Notice and Agenda

Hartford City Plan Commission
Common Council Chambers
Lower Level City Hall - 109 North Main Street

Date: August 10, 2020 Time: 5:30 p.m.

Title: Discussion and Consideration of a Proposed Wall Sign in the Business Improvement District – Creations 101, 302 N. Main Street

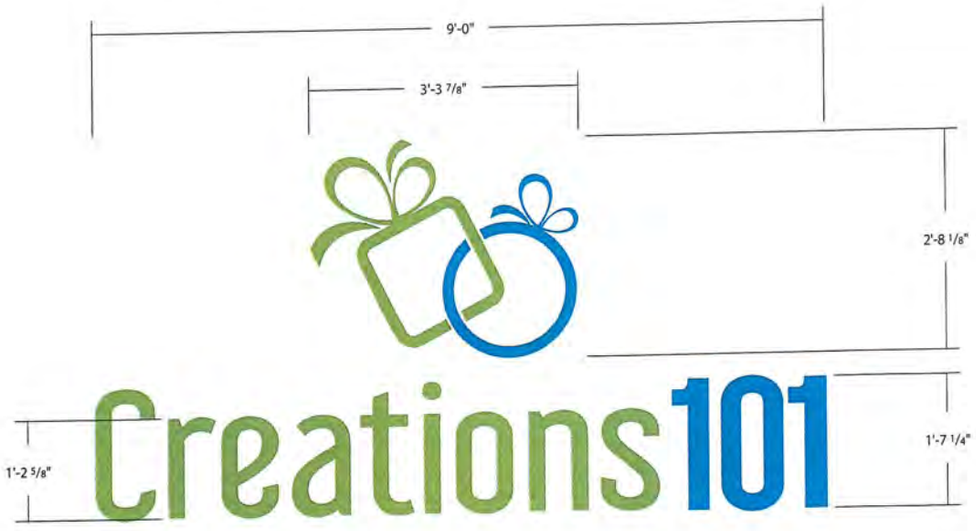
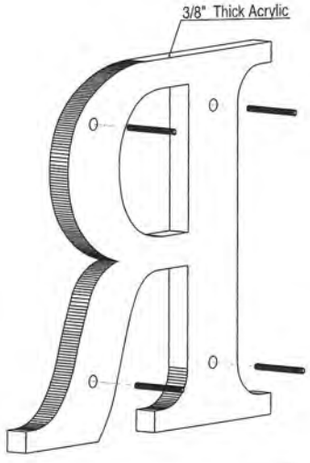
The sign is composed of painted acrylic letters and logo. Lettering is below a stylized square/circle gift logo. Two colors are used, a bright green to the left ("Creations" and the square) and a mid-range blue to the right ("101" and the circle). The sign measures 43 square feet, below the maximum square footage allowed, and is correctly placed within the signable area. The sign is not illuminated.

There is minor concern regarding the choice of colors. The green is very bright, not usually considered an acceptable choice in this Historic District. On the other hand, it presents well against the brown of the façade. The blue, while an acceptable color in itself, fades into the façade a bit. The lettering, logo and colors are already established for the business and the issue is not problematic enough to recommend a change.

Recommendation: The Planning Staff recommends approval of the wall sign for Creations 101, 302 N. Main Street.

Title: Concept Plan Review of a mixed use residential development located on North Main Street north of the Pheasant Run Town Subdivision

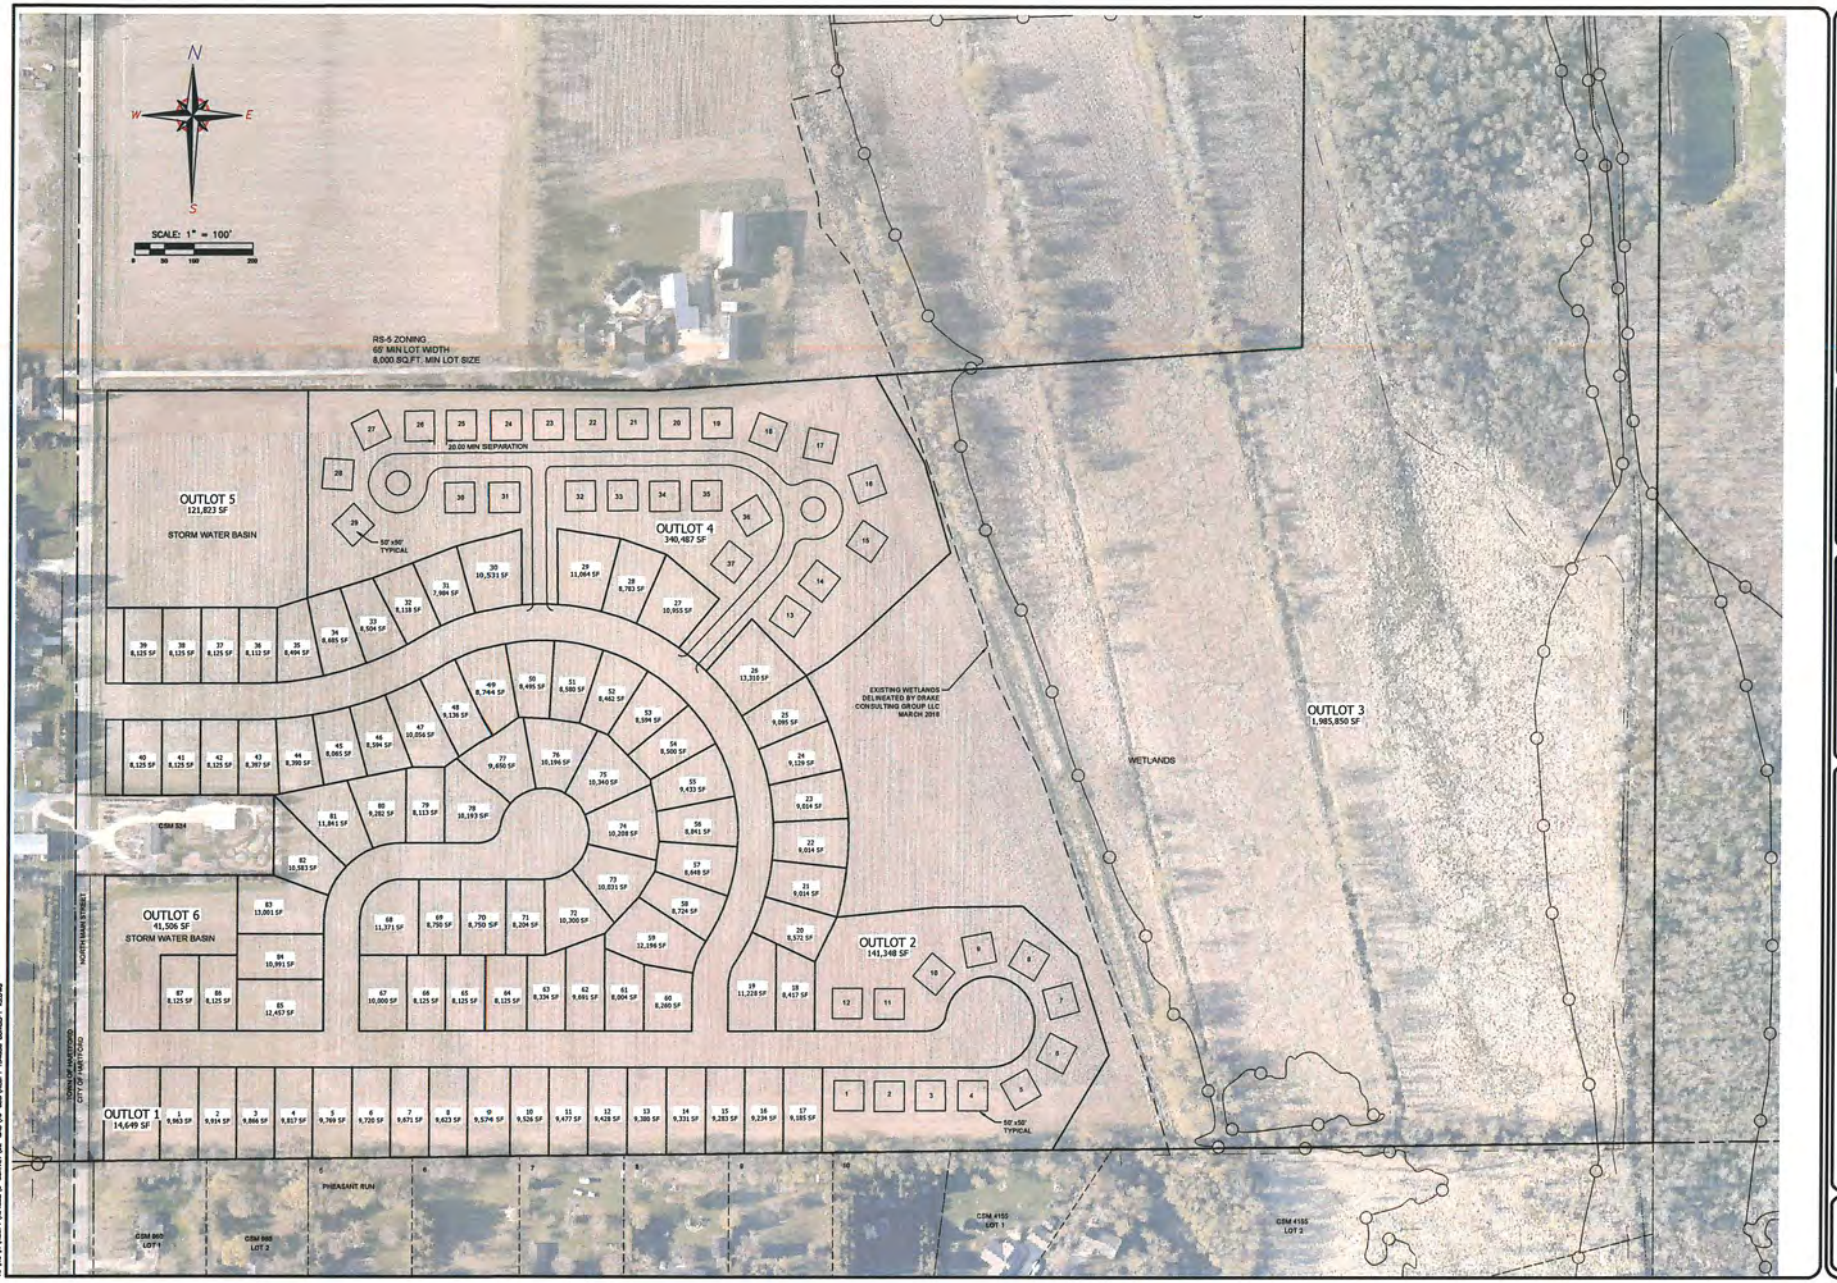
The proposal shows two entrances from North Main Street with the two-family units located at the southeast and north/northeast portions of the property.

The adopted Smart Growth Plan identifies this area for medium density residential development at a density of 1.1-2.9 units per acre. The proposal adheres to the Smart Growth Plan (2.9 units per acre proposed). Staff believes that the proposed number of units, mix of units and subdivision layout would work well on the property and would be a welcome addition to the City.

The single-family lots proposed have a minimum size of 8,125 square feet and would meet the minimum area requirements of the Rs-4 District with a Planned Unit Development. The width of the lots is not included in the proposal. The Rs-4 District requires a minimum of 80 feet. If the lots are narrower than 80 feet, the Developer may need to petition for Rs-5 zoning for the single-family lots as part of their request to have permanent zoning assigned to the development. The two family units would require a rezoning to Rd-2 Two-Family District.

The Development proposes two public streets intersecting with North Main Street. Based on the distance from other streets and driveways, the proposed street locations appear acceptable. The duplex units on Outlot 4 are proposed to be accessed by two private driveways similar to the Conservancy Development on South Wilson Avenue and the Fox Haven and Willow Glen condominiums on East Loos Street.

As per all of the City's residential developments, sidewalk would be required on both sides of all streets. Staff also recommends requiring sidewalk on the east side of North Main Street from the southern street in the development to Yellowstone Drive in the Borlen Farms development. The sidewalk should be able to be placed within the existing North Main Street Right-of-Way (ROW).

The property slopes down to the west, north and east from a high point on the south central portion of the property Substantial grading of the property is likely necessary and a more thorough review of a detailed grading and stormwater management plan would take place as part of a preliminary plat review. Outlots 1, 5 and 6 and the western portion of Outlot 3 are expected to be stormwater management areas.

Electric Power is available from the Borlen Farms Subdivision. This development isn't contiguous to Hartford Electric's service territory and in order to serve the development, Hartford Electric would need to reach a service area agreement with WE Energies.

The Utility Director is assuming a 12" water main will be extended to serve the development, and that there should be adequate pressure and flow in this area. Water main would be extended to the development within the North Main Street ROW from Borlen Farms and would be done at the Developer's expense.

Sanitary main would be extended to the development within the North Main Street ROW from Borlen Farms and would be done at the Developer's expense. A sanitary lift station and / or grinder pumps may be needed, and Staff will continue to work with the Developer as they fine tune the sanitary sewer plan.

Recommendation: The Planning Staff recommends APPROVAL of the Concept Plan for of a mixed use residential development located on North Main Street north of the Pheasant Run Town Subdivision as presented.

Title: Discussion and Consideration of a Rezoning Request for Two Lots on Stonecrop Drive, Windsong Crossing Subdivision

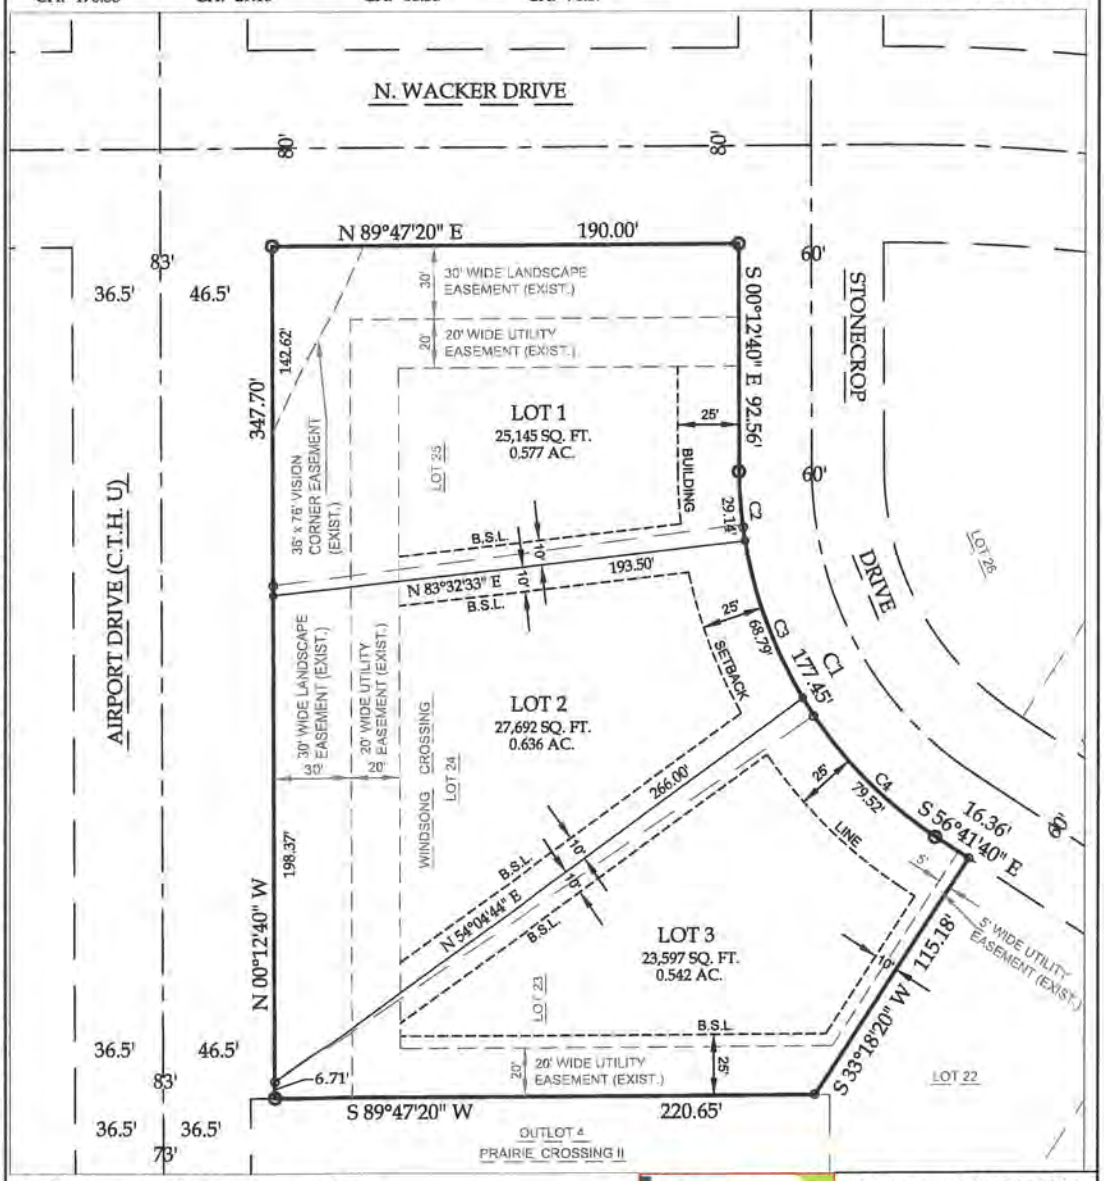
Background: Hillcrest Stonecrop has requested the rezoning of land described as lots one and two of the attached proposed Certified Survey Map (CSM), subject to the recording of said CSM. The two lots are currently lots 24 and 25 of Windsong Crossing subdivision, plus a small portion of lot 23. The proposed certified survey map adjusts the south boundaries of current lots 24 and 25 to create lots 1 and 2, which results in current lot 23 losing some land along its north lot line when it becomes lot 3 of the new CSM.

Hillcrest Stonecrop has requested the rezoning of these two proposed lots to single family: Rd-2 Two Family Residential to Rs-4 Single Family Residential. Hillcrest Stonecrop owns the three lots and several duplex lots across Stonecrop Drive, and is in the process of building out and creating a condominium development for the duplexes. The company has customers interested in single-family construction on the proposed lots 1 and 2. Proposed lot 3 will remain Rd-2 zoning.

The properties are surrounded by two-family zoning to the north, single family to the north and west, and duplex zoning to the south and east. The properties meet size requirements for Rs-4 zoning.

City Staff believes that a deadline of December 31, 2020 for recording of the certified survey map is reasonable and recommends same as a condition of approval.

Recommendation: The Planning Staff recommends approval of the rezoning request to Rs-4 Single Family District for Lots 24, 25 and a portion of lot 23 in Windsong Crossing subdivision as shown in the attached proposed Certified Survey Map, subject to the recording of said CSM prior to December 31, 2020.

Title: Site Plan Review – Hartford Union High School Driveway and Parking Changes.

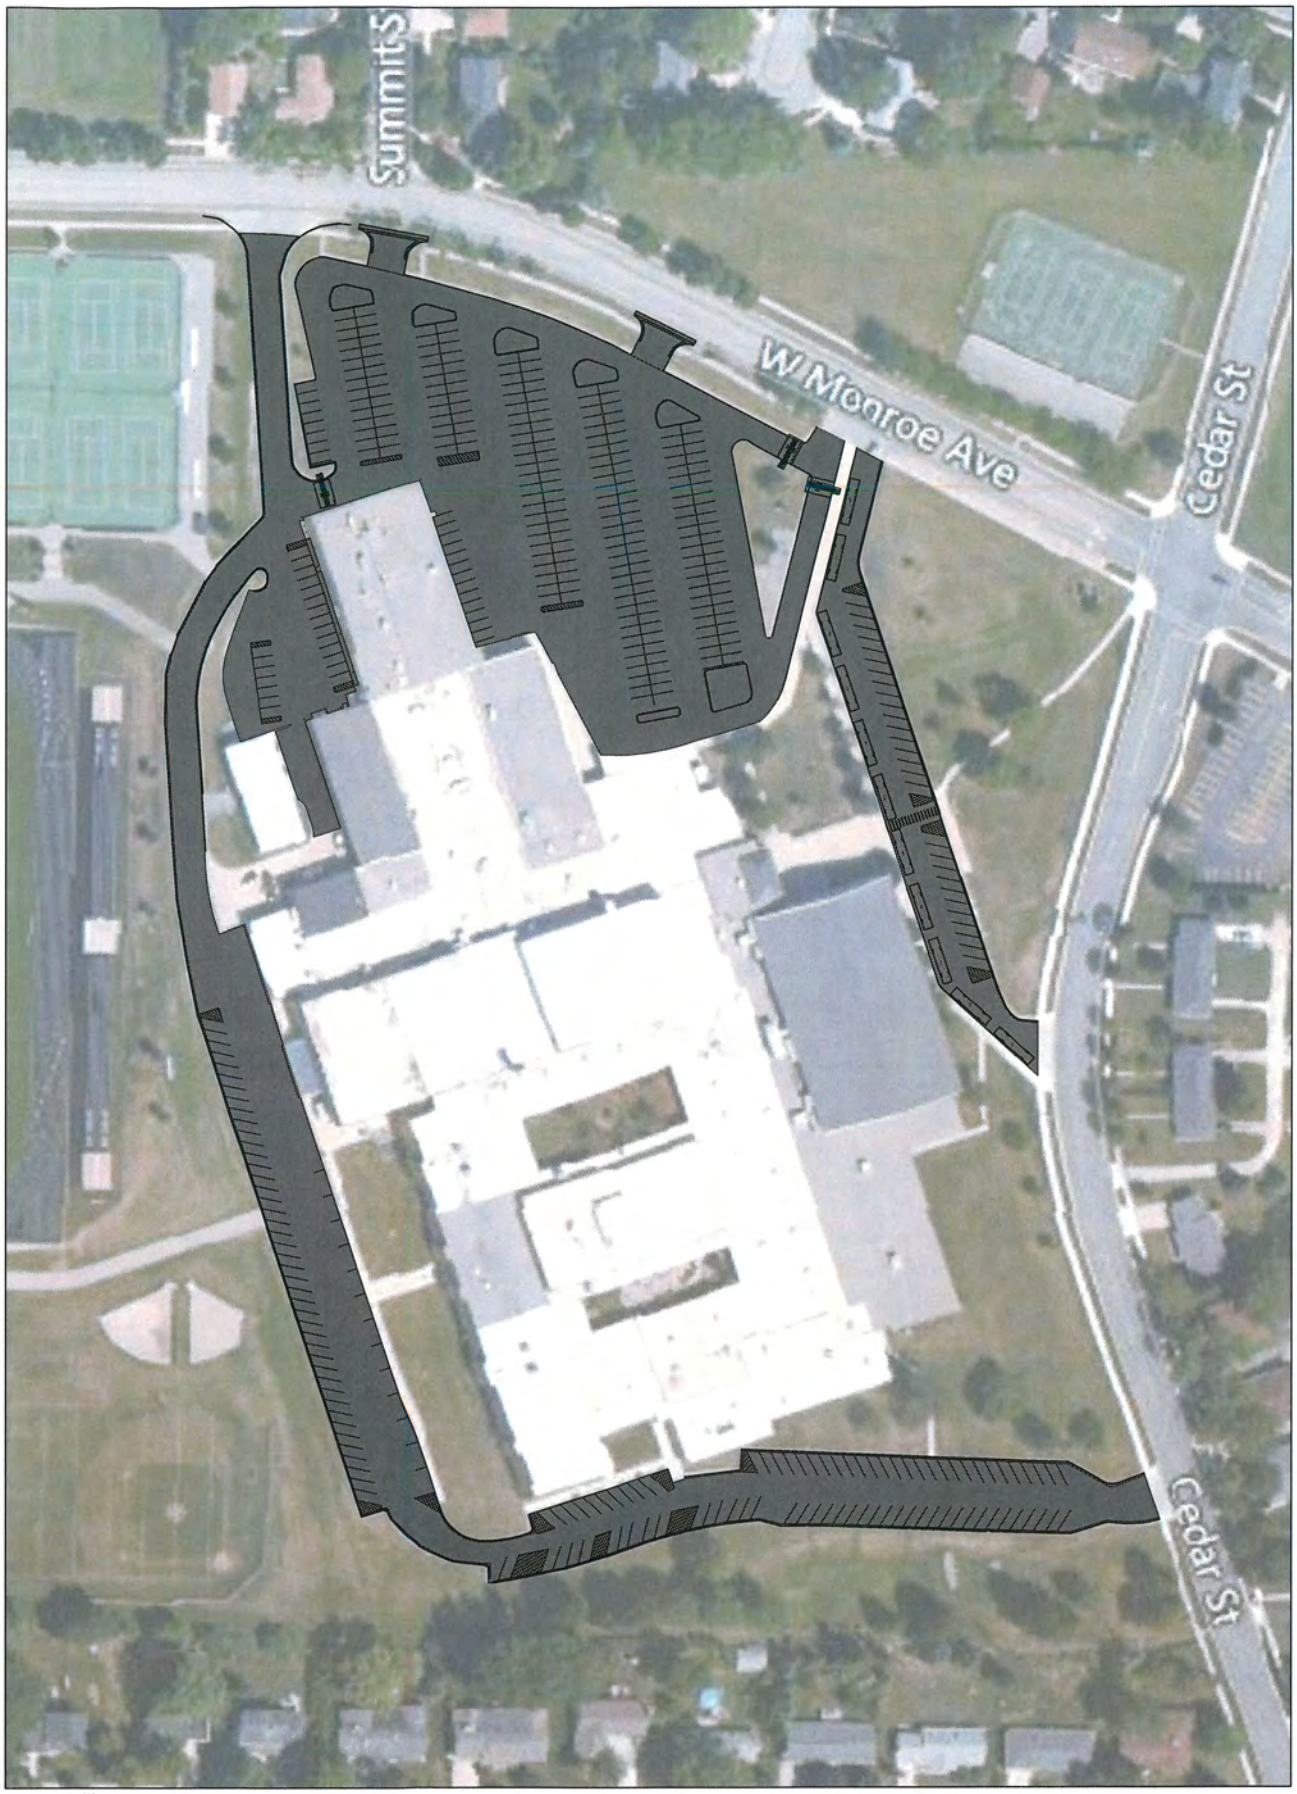
- The new driveways would meet the minimum distance between driveways.
- The new driveways would meet the maximum width allowance.
- The school and their engineers believe that traffic flow would be improved by separating the large parking lot from the lot that goes around the south and west of the school.

- The parking lot and driveway on the south and west side of the school would be entrance only from Cedar Street and exit only onto West Monroe Avenue.

- Staff's only concern is the proximity of the two driveways on the northwest side of the site and the potential for many vehicles exiting onto West Monroe Avenue from both driveways. However, given that the northwest side of the large parking lot is identified primarily as staff parking (and staff generally leave later than the students), Staff believes that the proposed configuration can work.

- If this area becomes a traffic ingress/egress issue, Staff will work with HUHS to identify and implement solutions.

Recommendation The Planning Staff recommends APPROVAL of the site plan for the Hartford Union High School Driveway and Parking Changes.
